ISSUED FOR PERMIT ONLY

Old Town 7-11/Strip Center
Addison, Texas
Ben Pinnell

A1.1
OF SHEETS

01 SITE PLAN
1"=10'-0"

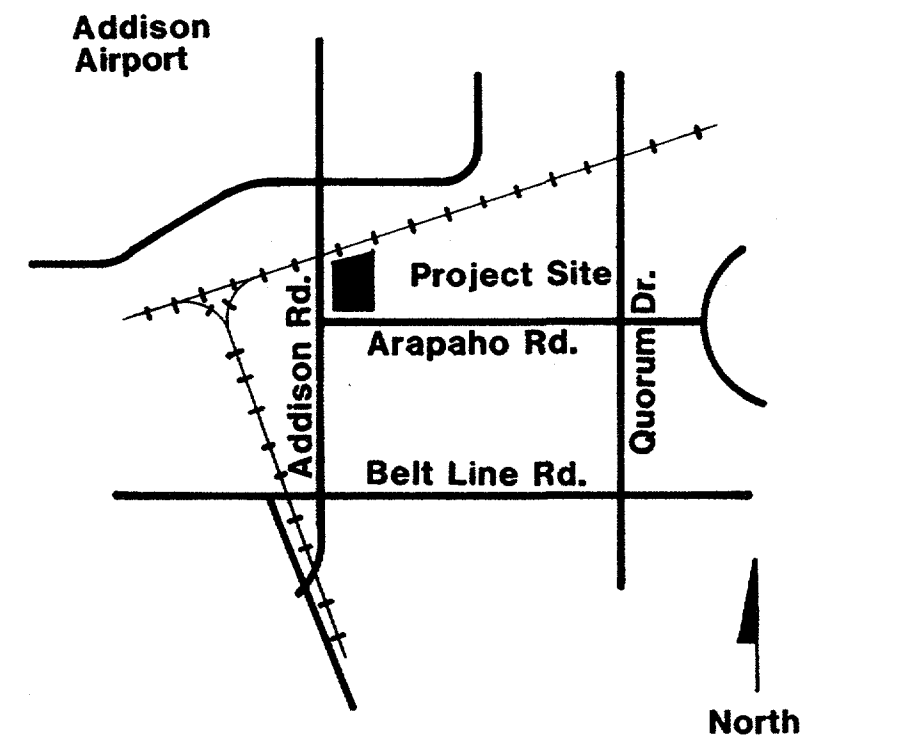
WHERE WILL UNDERGROUND GAS STORAGE TANKS BE LOCATED?

03 SECTION
1 1/2"=1'-0"

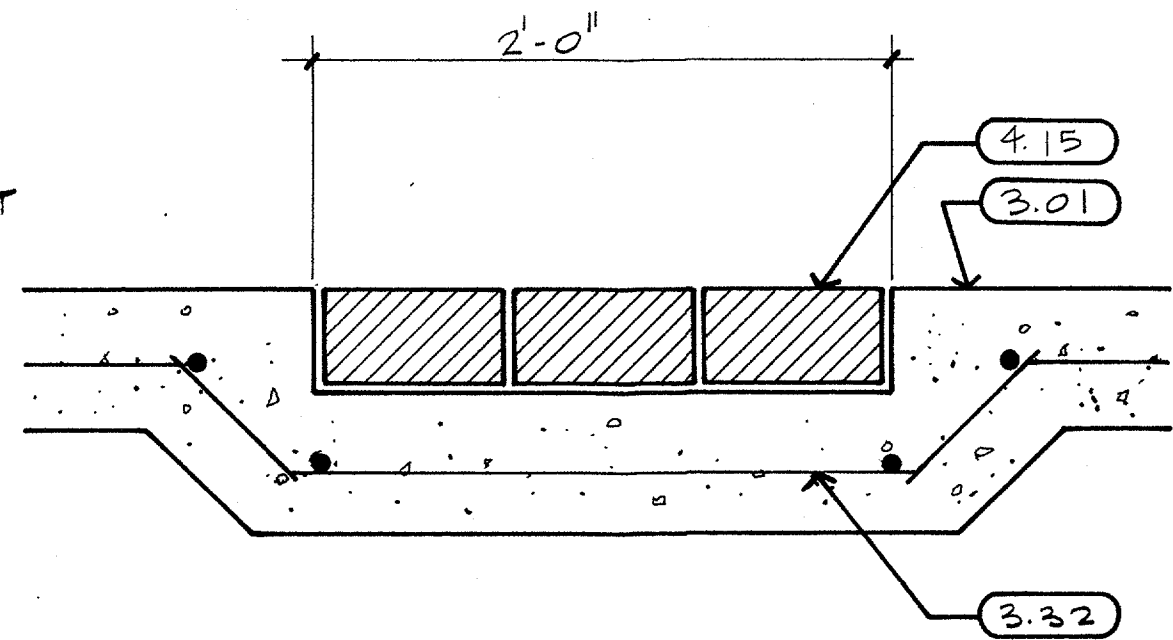
HOLD
1. SUBMIT F.A. HEIGHT APPROVAL.
2. STRUCTURAL PLANS MUST BE SEALED BY ENG.
WILL BE SUBMITTED @ LATER DATE PER JOHN BARRETT, E.O.I.
